Field campaign

Topic	Flying Spur - Top View and Rear View Cameras - Images Blurred (RE20/21)
Market area	United States E05 Bentley USA and rest America (6E05)
Brand	Bentley
Transaction No.	2060304/2
Campaign number	RB63
Note	
Type	Recall Campaign
US code

Addition of a drain hole within the Rear View Camera securing bracket.

Figure 2

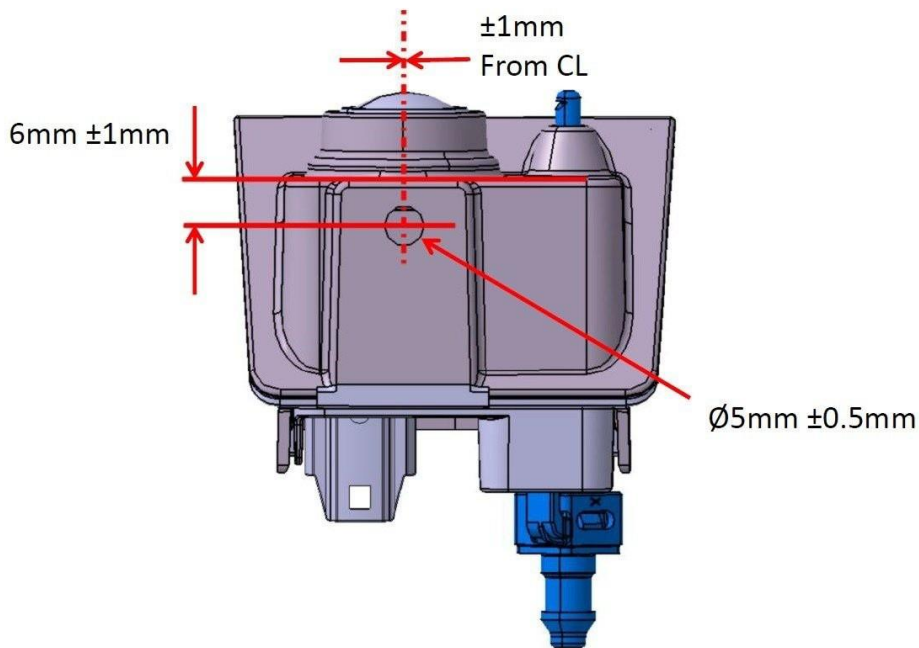
2) Mark the location for the drain hole on the rear view camera bracket – figure 2.

IMPORTANT: Do Not drill the hole with the camera fitted into the bracket.

- Using a 5mm drill bit, drill through the camera bracket, ensuring the dimensions in Figure 2 are strictly adhered to.
- Leave the camera and bracket to dry at room temperature for a minimum of four hours.
- Fit the camera back into the bracket assembly – ensuring all fastenings are correctly made.

Figure 3.

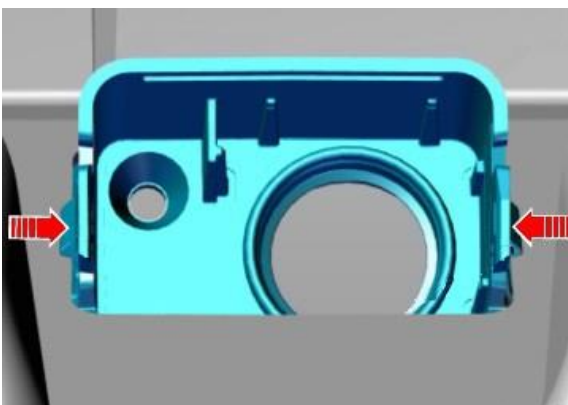
Refer to *Repair Group 94 – Lights, lamps, switches outside – Camera system - Reversing camera - To remove and fit* - apply 3M Scotch-Weld Epoxy Clear Adhesive to the locating tabs as shown – figure 3.
